RE: Comments of Friends of Nelson and Ernest Reed, Interveners

RE: the Draft Environmental Impact Statement for the Atlantic Coast Pipeline and Supply Header Project (Docket Nos. CP15-554-000, CP15-554-001, and CP15-555-000 FERC/EIS-0274D)

**FIGURE 2** – Phases of the HDD process as presented in the HDD Design Report prepared for Dominion Transmission, Inc. by J.D. Hair & Associates, Inc. (7/27/16). The depiction shows the more-common use of HDD for installing pipelines under rivers or other water bodies.

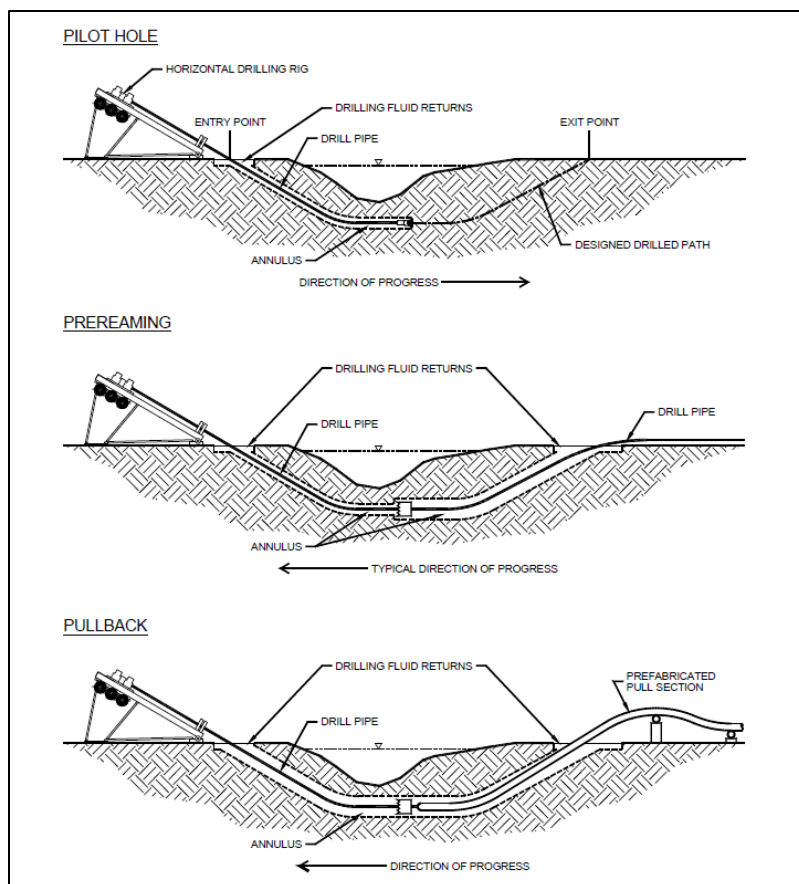
Our objection to the proposed Blue Ridge crossing is much like that for other areas of the ACP project. Large-scale forest clearing and excavation on steep mountainsides presents substantial risk of erosion and sedimentation, alteration of runoff properties, and landslides. FERC, however, has failed to require detailed plans for construction and mitigation prior to publication of the DEIS, thereby precluding informed public and regulatory agency analysis of risks, alternatives, and mitigation measures.

The proposed HDD and contingency DPI installations will require extensive excavation for creation of level workspaces, access roads, and areas for pipe fabrication, testing, staging, and pullback. The information included in the DEIS, however, does not disclose

**FIGURE 5** – Extreme pullback required for the proposed Blue Ridge HDD.

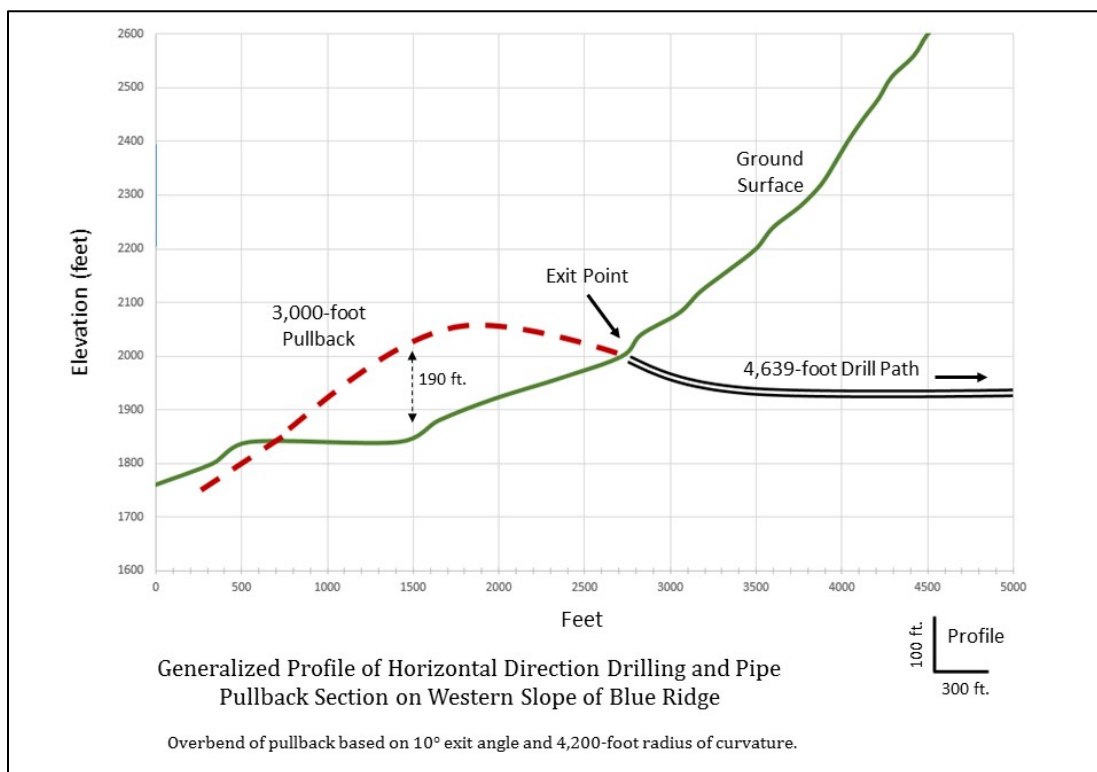
The proposed mountainside HDD operation greatly exceeds what is required for typical HDD operations on relatively flat ground. For example, see **Figure 6**.

**FIGURE 7** – Profile of the proposed Blue Ridge HDD showing the exit-side suspension of pullback pipe based on a 1,500-foot bend radius instead of the correct 4,200-foot bend radius. From Geotechnical Site Investigation Report for Atlantic Coast Pipeline –

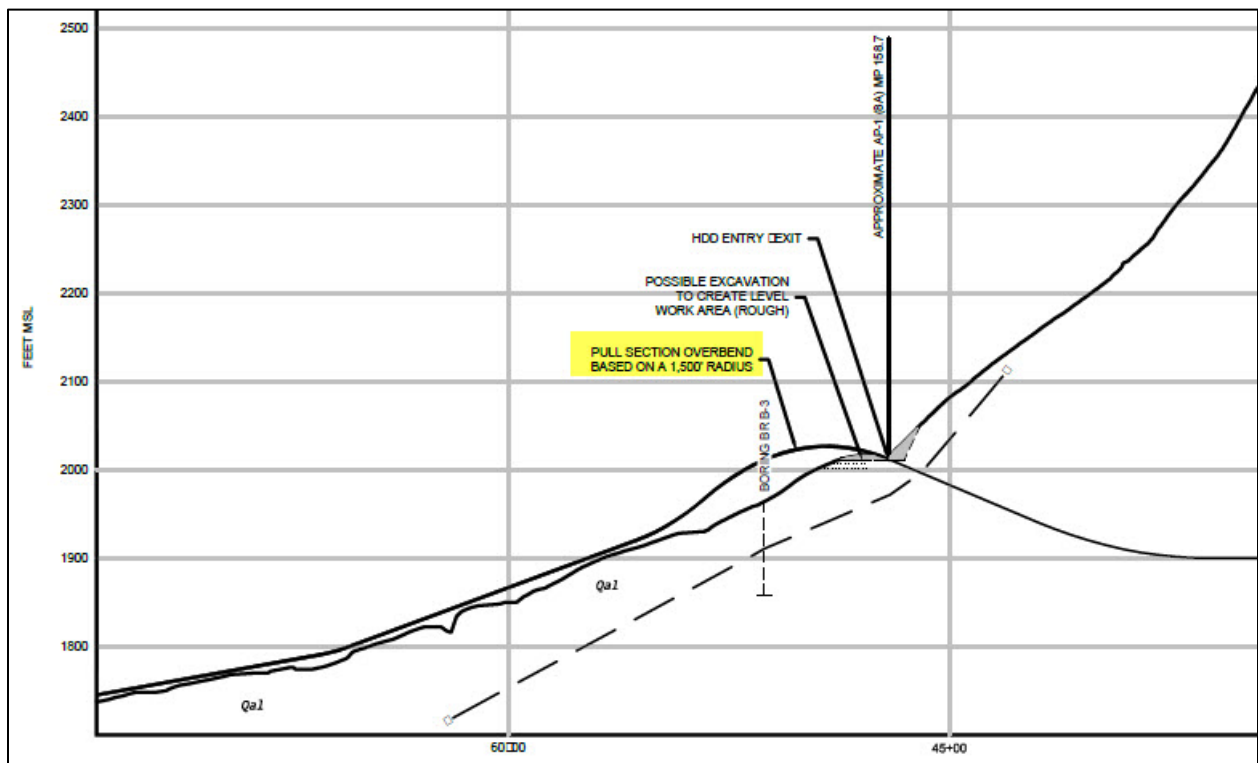
The fact that the suspension of pullback pipe and the magnitude of the related footprint were not addressed in the DEIS may be due to incorrect or misleading information provided to FERC by Dominion. The only depiction of the HDD pullback section included in Dominion submissions to FERC is based on a 1,500 foot bending radius (see **Figure 7**). This differs substantially from

**FIGURE 9** – Recommended exit-side and pullback pipe fabrication workspace.

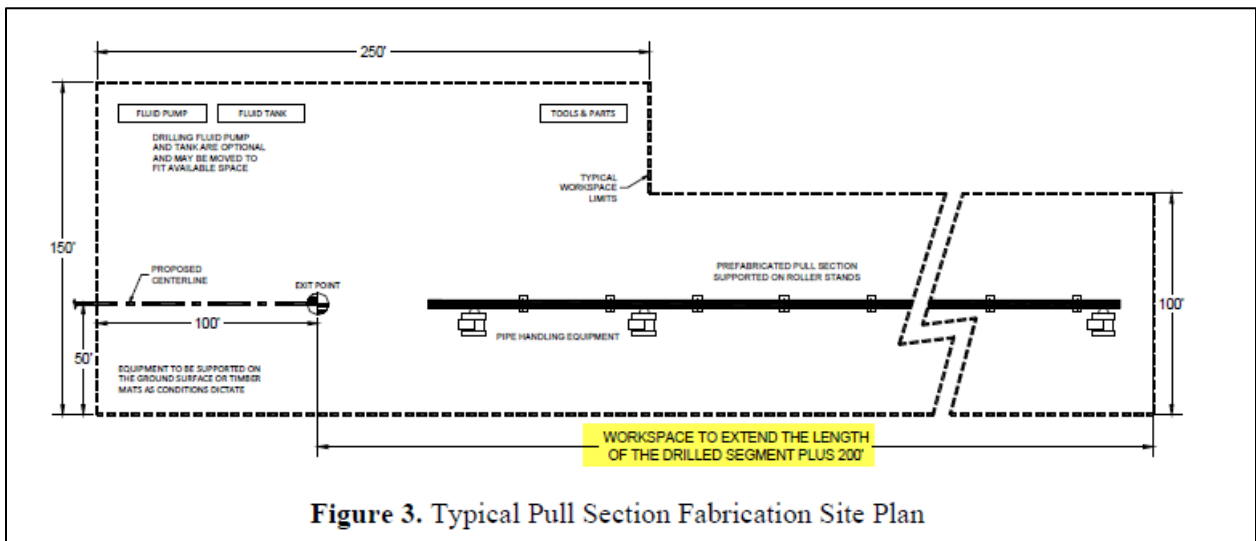
The length of the drilled segment for Dominion’s proposed HDD is 4,639 feet. The recommended pullback segment would thus be 4,839 feet. However, as indicated in the DEIS, the length of the workspace available for staging the pipe pullback is only about 3,000 feet, which makes fabrication, hydrostatic testing, and pullback of the recommended single continuous pipe string impossible.

**FIGURE 11** – Locations of subsurface borings and geophysical surveys conducted for the proposed Blue Ridge HDD crossing. From *Geotechnical Site Investigation Report for Atlantic Coast Pipeline Horizontal Directionally Drilled Crossing, Blue Ridge*

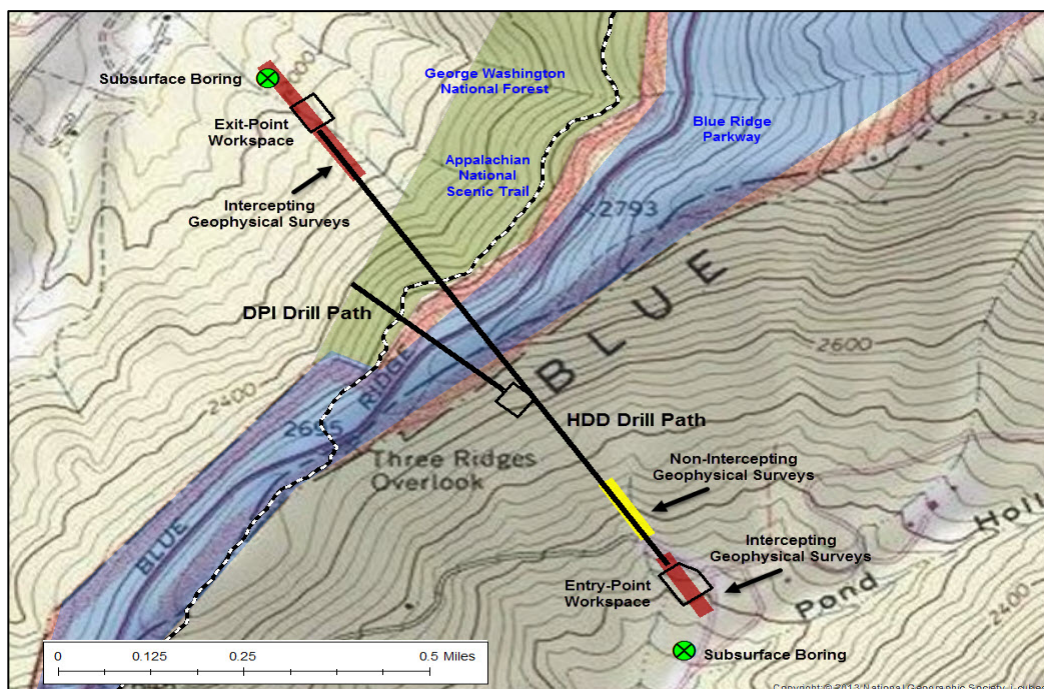
subsurface borings, the surveys indicated the presence of faulting and fractured rock at greater depth.<sup>68</sup> The survey results indicated that approximately 100 feet of fractured rock associated with a fault would be encountered at approximately 160 feet from the west-side exit point. Another fault of undetermined extent, was estimated to be present in the drill path beginning at approximately 425-550 feet from the ground surface at the east-side entry point.<sup>69</sup>

**FIGURE 12** – Interpreted results of geophysical surveys conducted at the entry and exit-sides of the proposed HDD drill path. (Based on Geophysical Study for a Proposed Blue Ridge HDD Crossing Augusta and Nelson Counties, Virginia, prepared by ATS International, Inc., 4/12/16.)

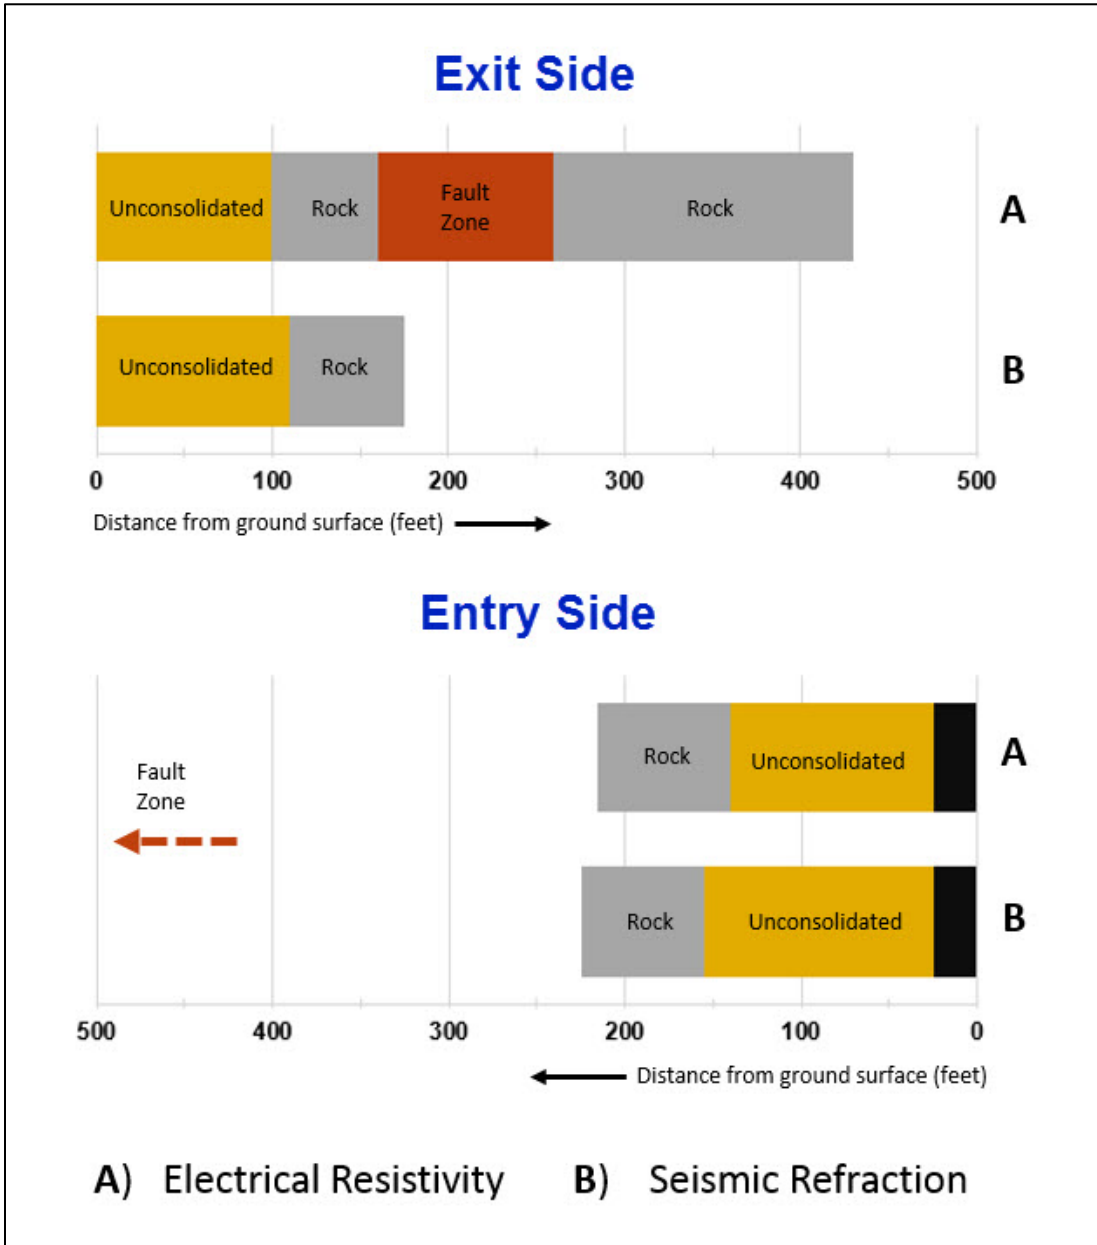
Results are shown for survey sections where imaging intercepted the projected drilling path. The fault zone in the entry-side section was estimated based on non-intercepting surveys, and was estimated to begin at 425-550 feet from the ground surface. The black-colored segments starting at the ground surface on the entry side indicate planned excavation. The total length of the projected drill path is 4,639 feet.

**FIGURE 13** – Construction-area slope and access-road grade classification for the Blue Ridge HDD and contingency DPI operations area.

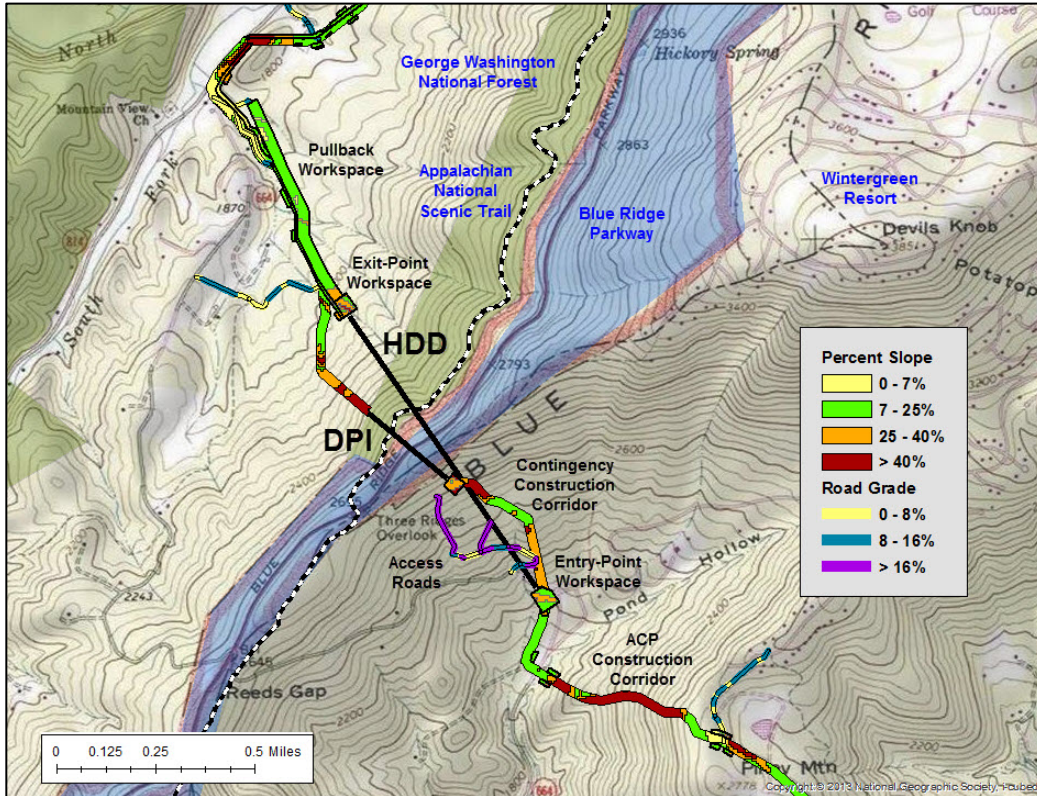
- Slope classification for the corridor and workspace areas is based on the following spacing criteria for right-of-way or runoff diversions (*Virginia Erosion and Sediment Control Handbook, 1992*).

The grade of the access road leading up to the entry-point workspace for the contingency DPI operation greatly exceeds recommendations for roads associated with oil and gas development (see **Figure 12**). This particular access road includes a 1,300-foot segment with grades that are continuously above 25% and partly above 40%.
